UNITED STATES
NUCLEAR REGULATORY COMMISSION
WASHINGTON, D.C. 20555-0001

SAFETY EVALUATION BY THE OFFICE OF NUCLEAR REACTOR REGULATION
RELATED TO AMENDMENT NO. 207 TO FACILITY OPERATING LICENSE NO. DPR-32
AND AMENDMENT NO. 207 TO FACILITY OPERATING LICENSE NO. DPR-37
VIRGINIA ELECTRIC AND POWER COMPANY
SURRY POWER STATION, UNIT NOS. 1 AND 2
DOCKET NOS. 50-280 AND 50-281

FIGURE 1

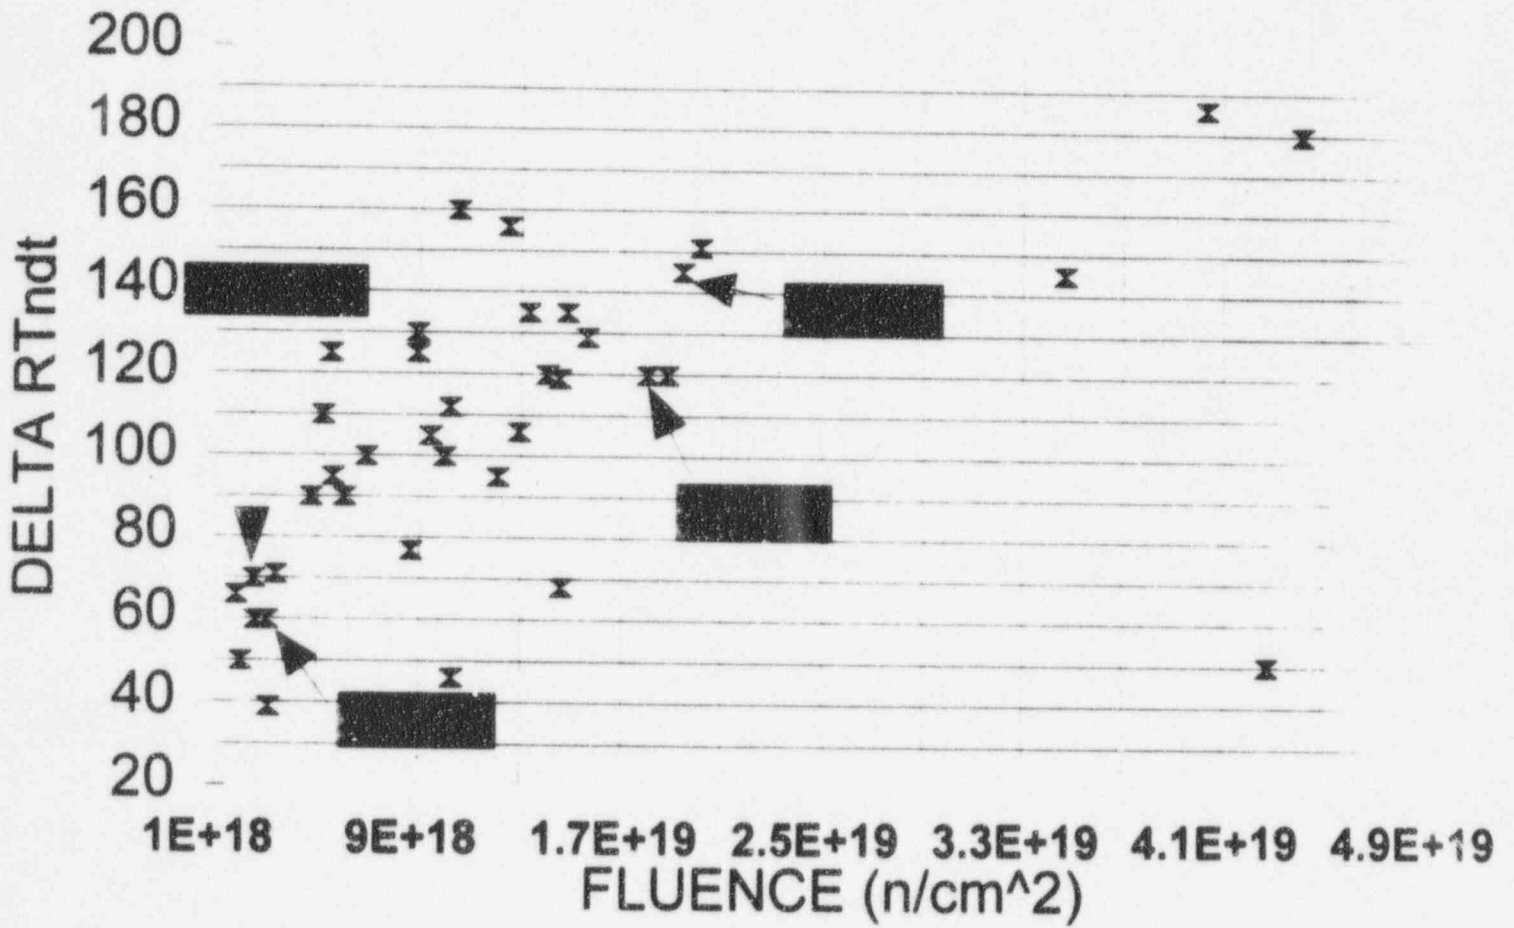
Comparisons of measured to predicted ΔRT_{NDT} values for all surveillance material are shown in Tables 1 and 2 for Units 1 and 2, respectively. The comparison of the measured to predicted ΔRT_{NDT} values indicate that all measured values are within one standard deviation (17°F for plates and 28°F for welds) of the predicted values which satisfies credibility criterion 3. Figure 1 shows ΔRT_{NDT} values vs. fluence for all correlation monitor materials from heat SHSS02 (heat designation in the Power Reactor Embrittlement Database (PREDB)). The material is from the Oak Ridge National Laboratory (ORNL) Heavy Section Steel Technology (HSST) program. The plot indicates that the surveillance data for the Surry Units 1 and 2 correlation monitor materials are within the scatter band of the entire material data base which satisfies credibility criterion 5.
